Errata for 2018 Uniform Plumbing Code Illustrated Training Manual – 1st Printing

The following are changes that we found after the first printing of the *2018 Uniform Plumbing Code Illustrated Training Manual*. These changes may apply to your code book. Thank you.

**FIGURE 310.1
PROHIBITED OR RESTRICTED FITTINGS**

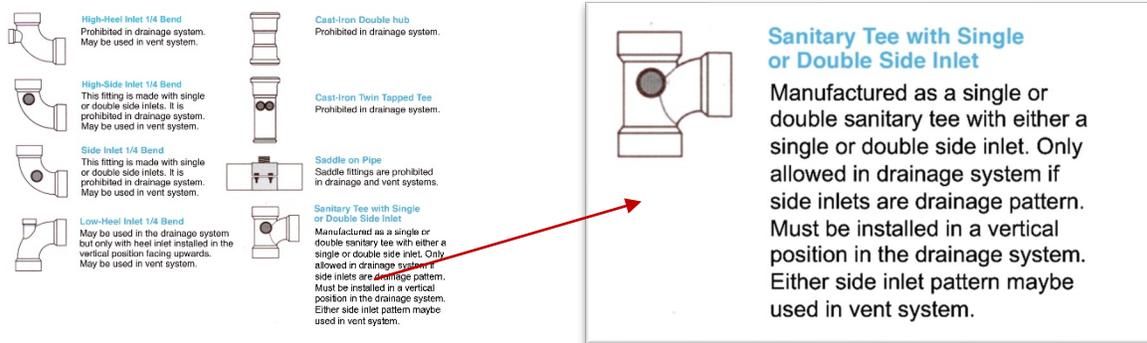
Figure 310.1 Prohibited or Restricted Fittings – The commentary in the figure for “Sanitary Tee with Single or Double Side Inlet” should be corrected as follows:

Manufactured as single or double sanitary tee with ~~we~~ither single or double inlet. ~~Prohibited in drainage system if side inlets are straight pattern. Only a~~Allowed in drainage system if side inlets are drainage pattern. Must be installed in a vertical position in the drainage system. Either side inlet patterns may be used in vent system.
